Re: Supplemental Photos, Marlboro Apartments, 1031 Marlborough, Detroit, MI

CONTINUATION/AMENDMENT SHEET
Historic Preservation
Certification Application

**MARLBORO APARTMENTS
BUILDING RENOVATION**

REVISIONS THIS SHEET

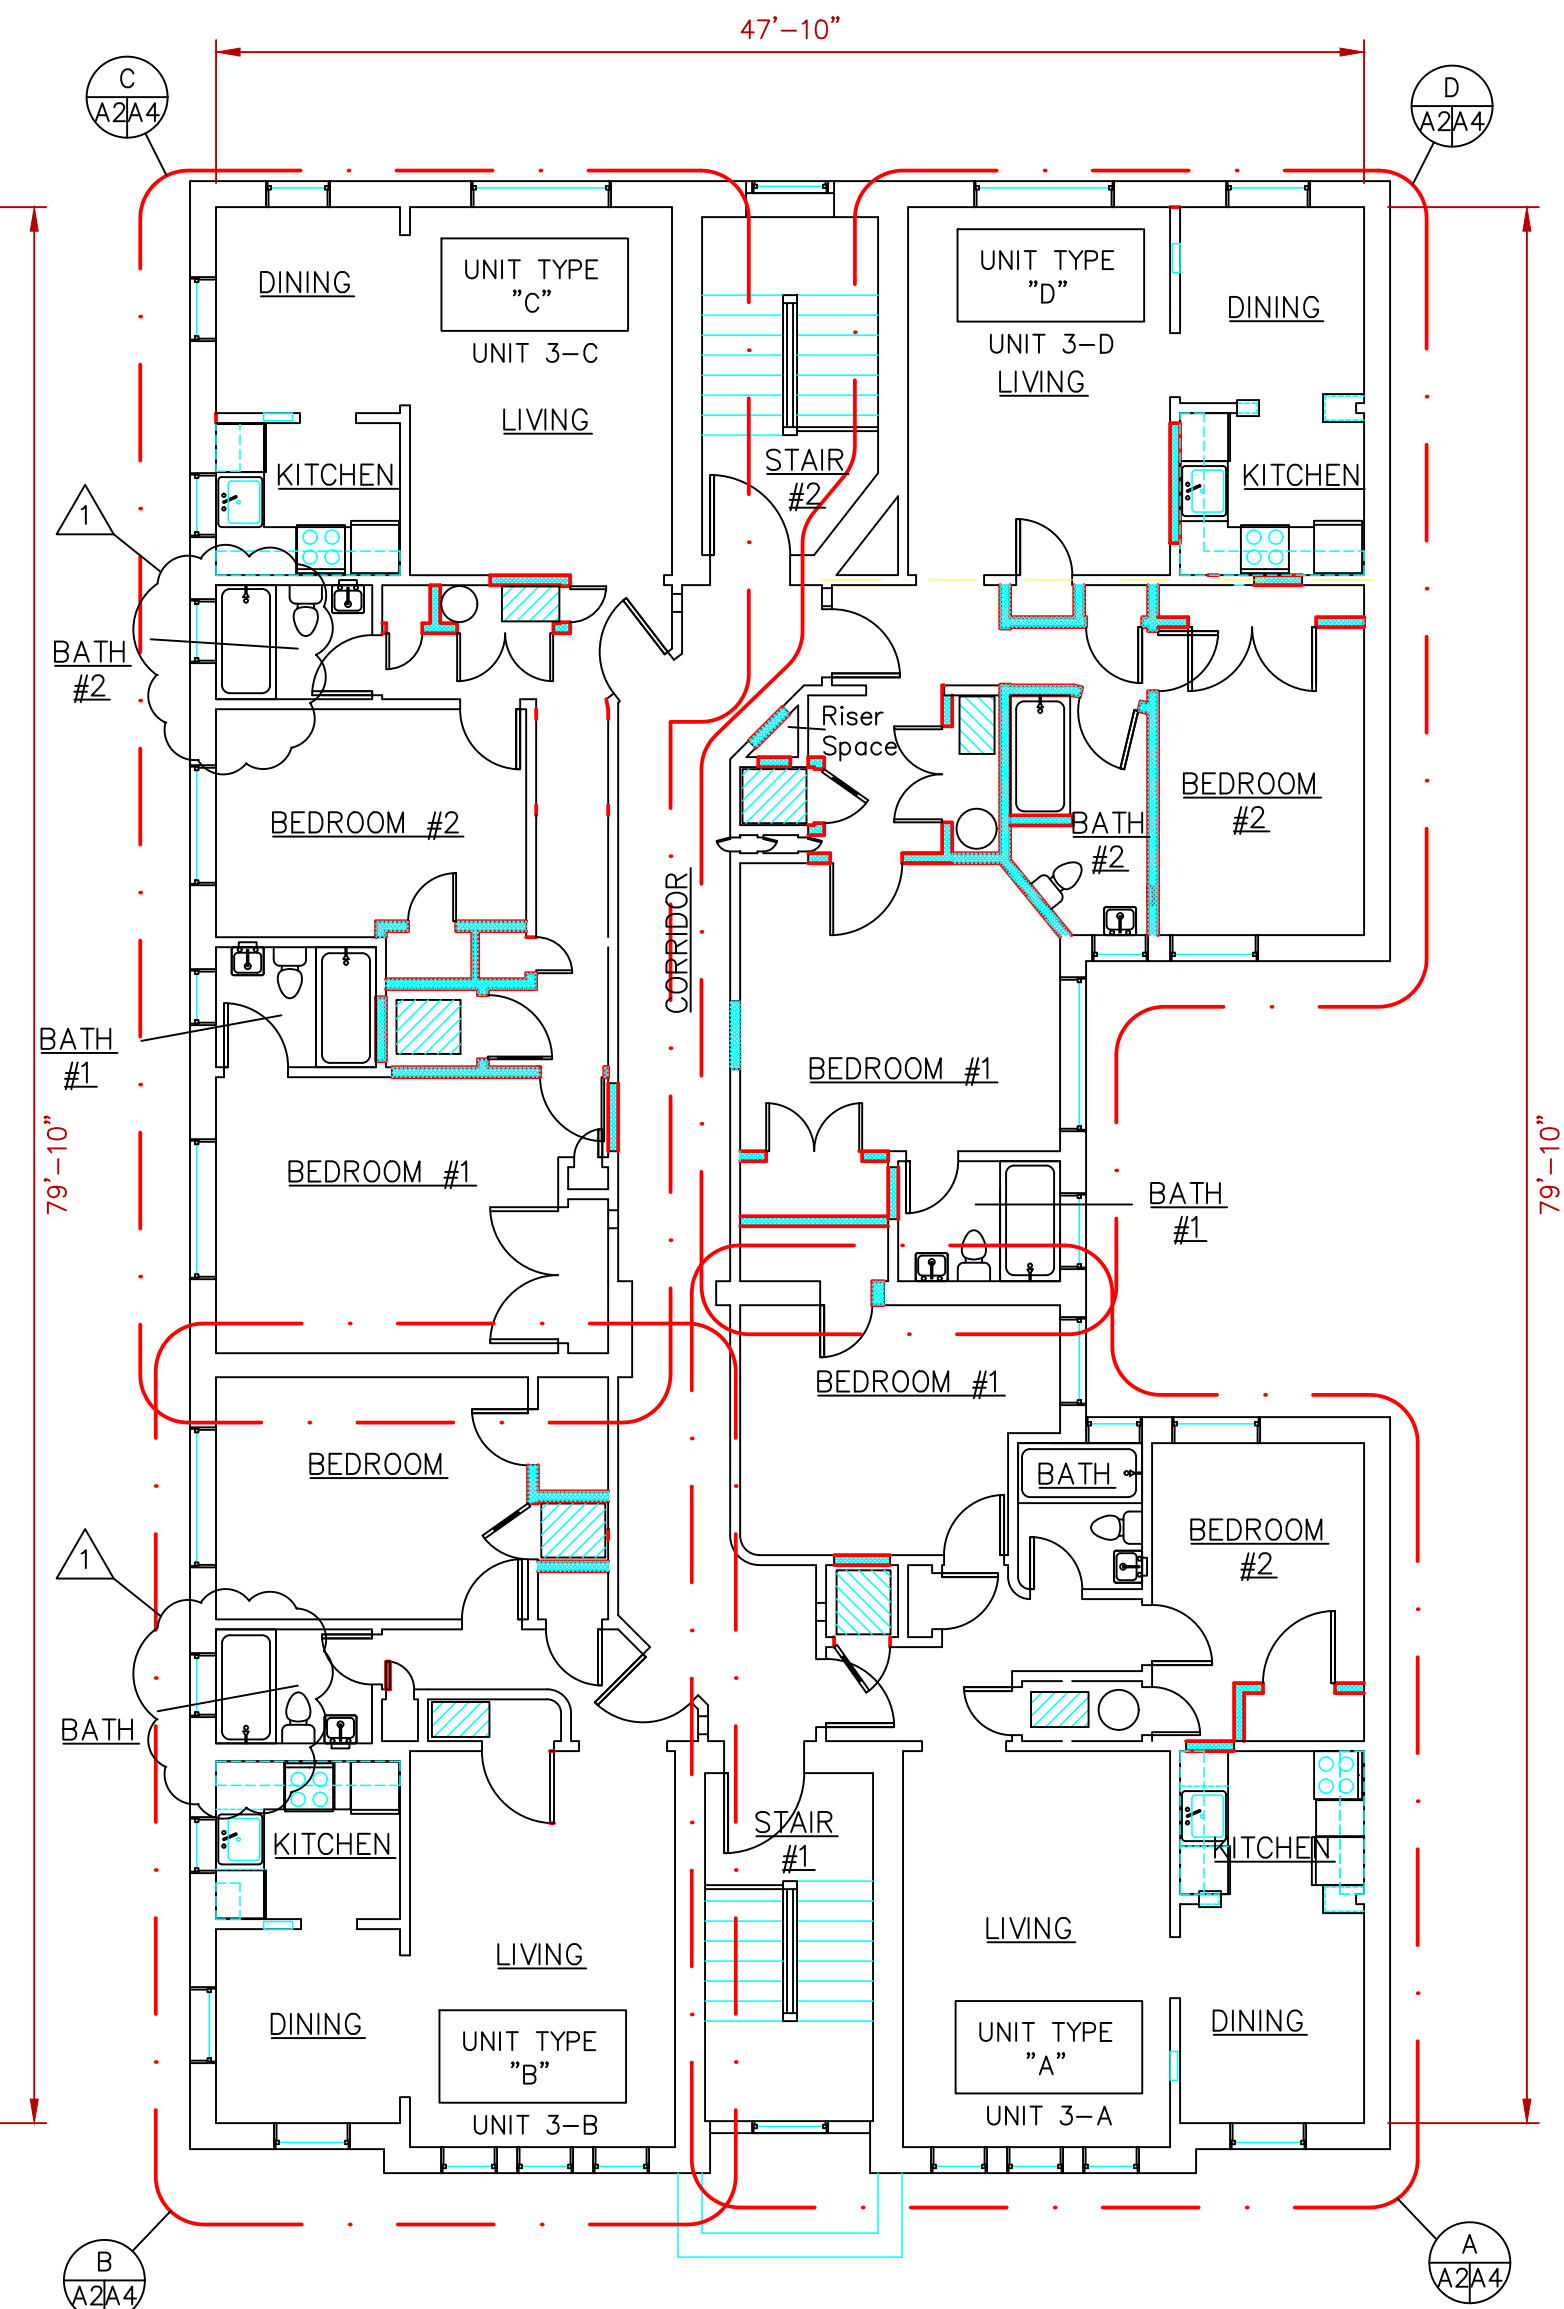
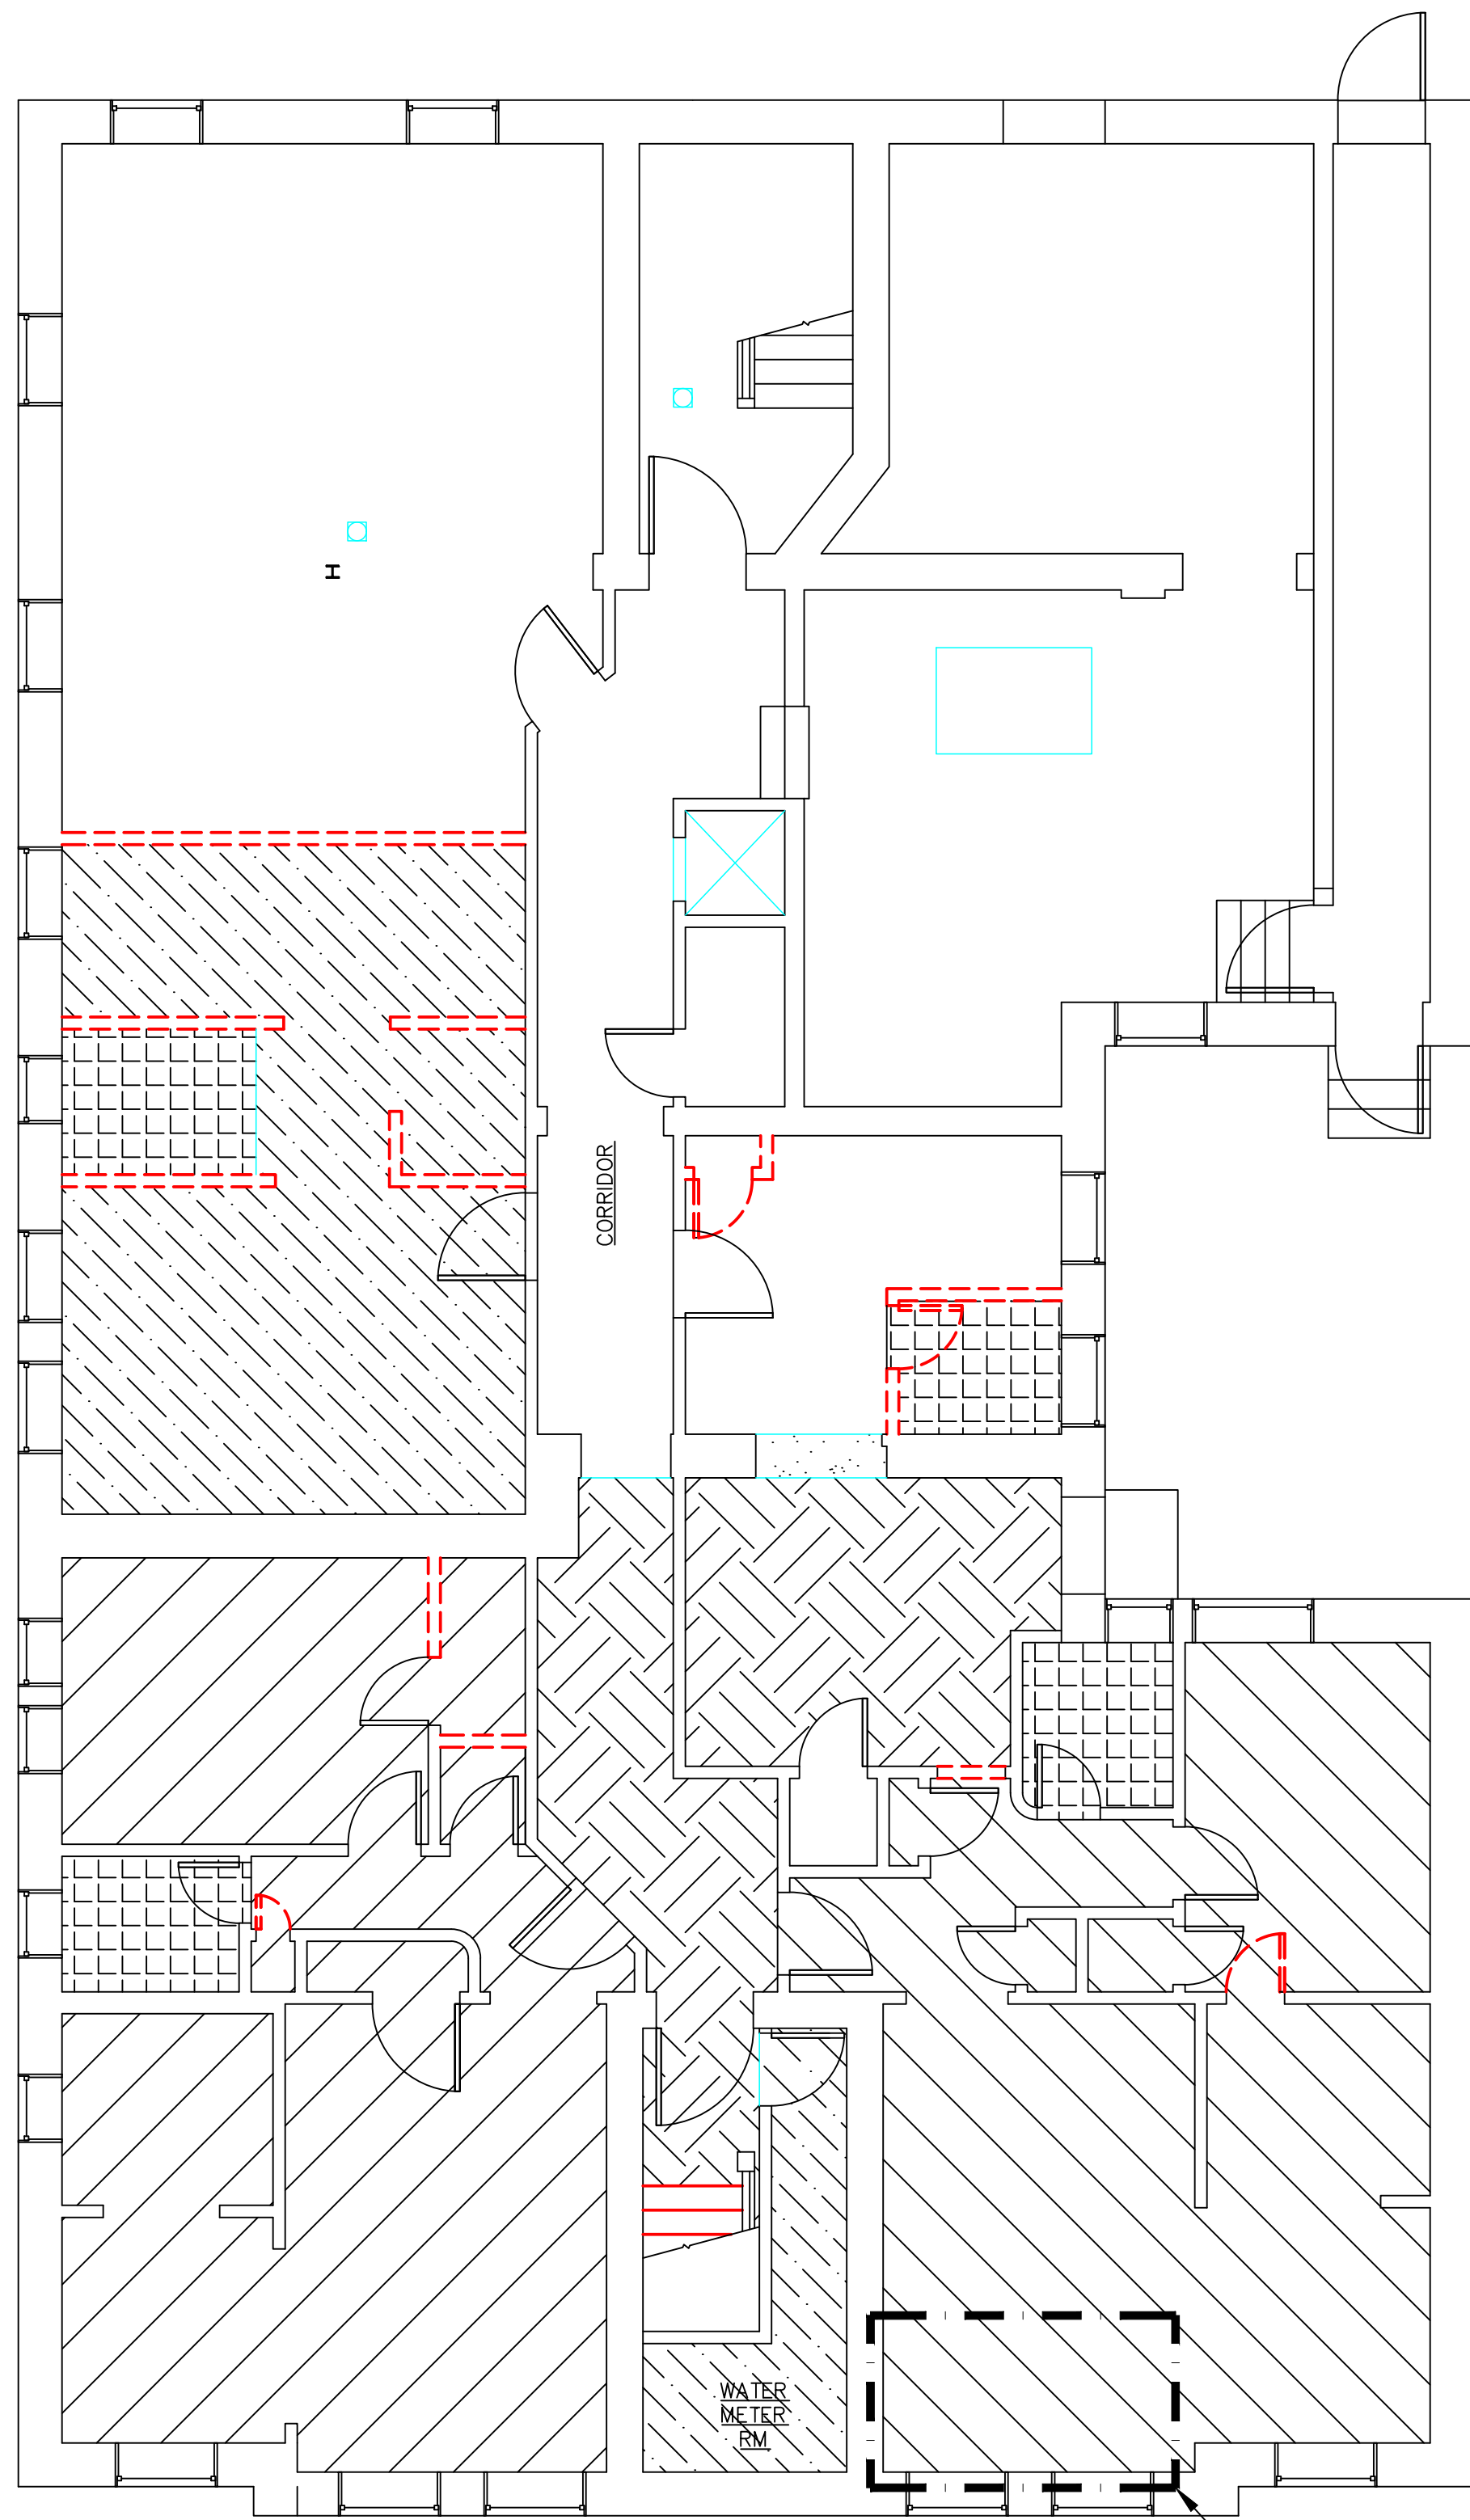
△ REVISED TUB/SHOWER UNIT SIZES

REVISIONS THIS SHEET

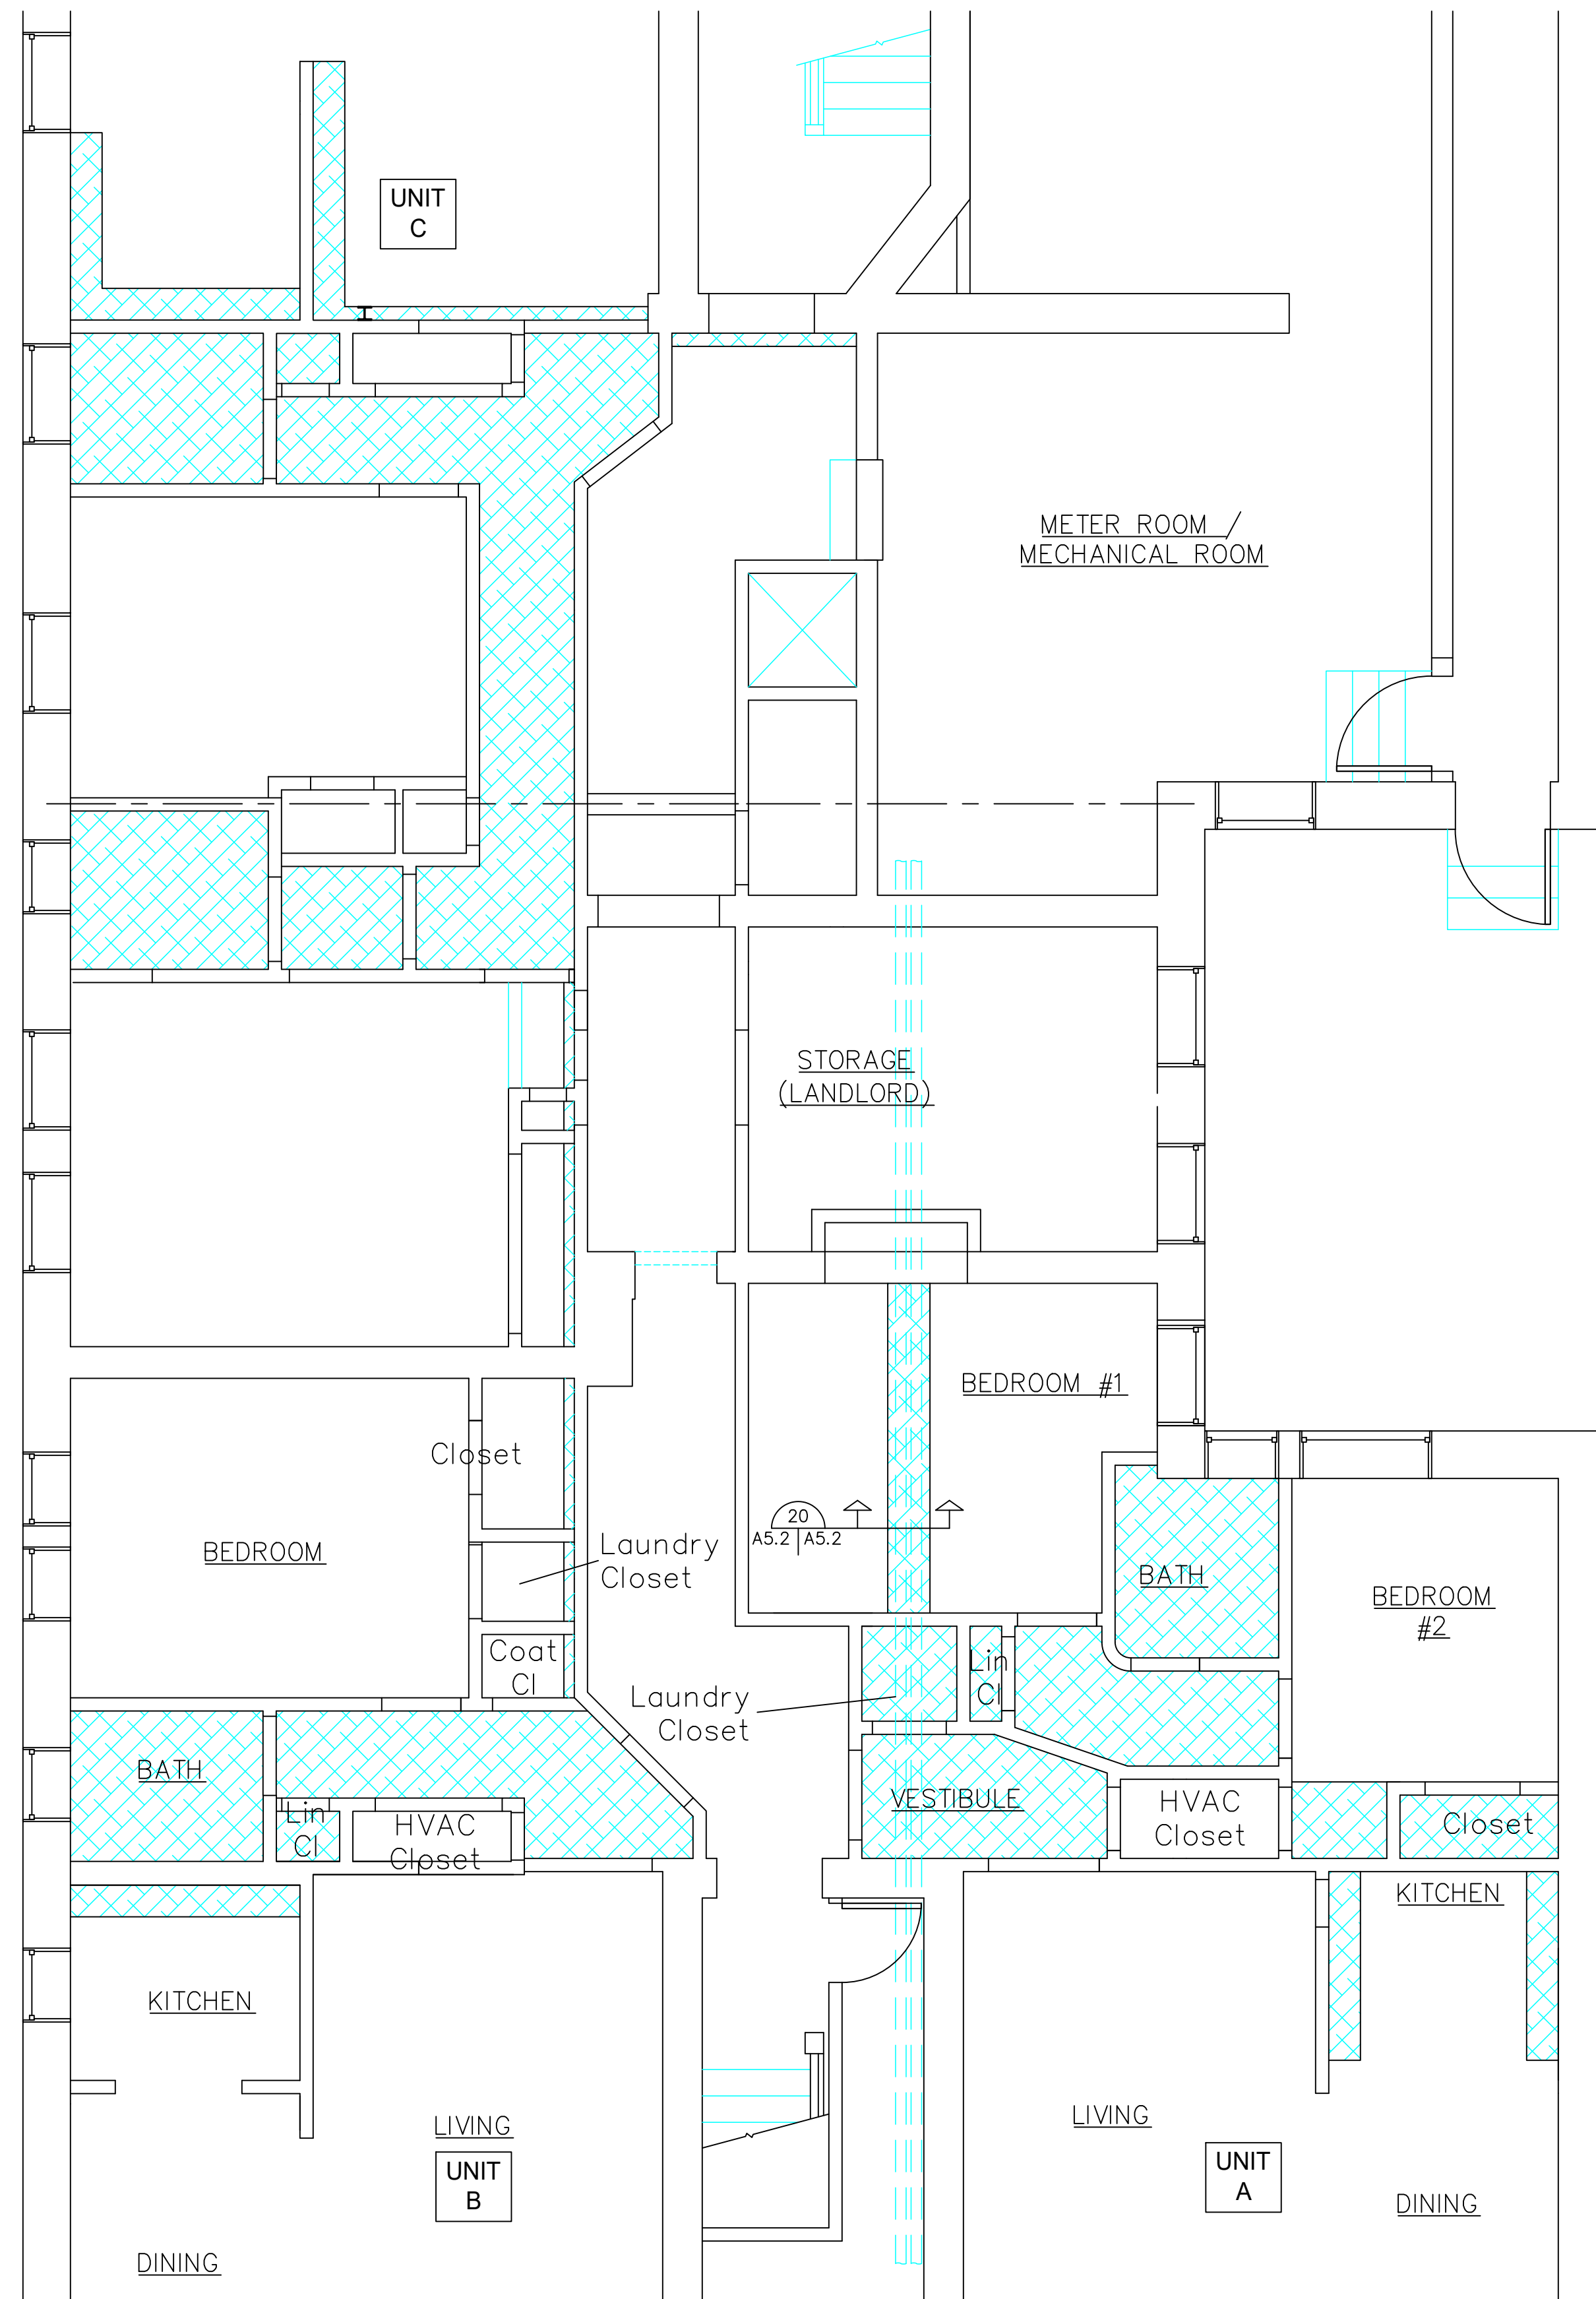
- CHANGED HEIGHT OF A PORTION OF THE BASEMENT HORIZONTAL PIPING CHASE. CHANGED WIDTH OF BASEMENT HORIZONTAL PIPING CHASE.
- ADDED CHART FOR FINDING CEILING PLANS BY LOCATION
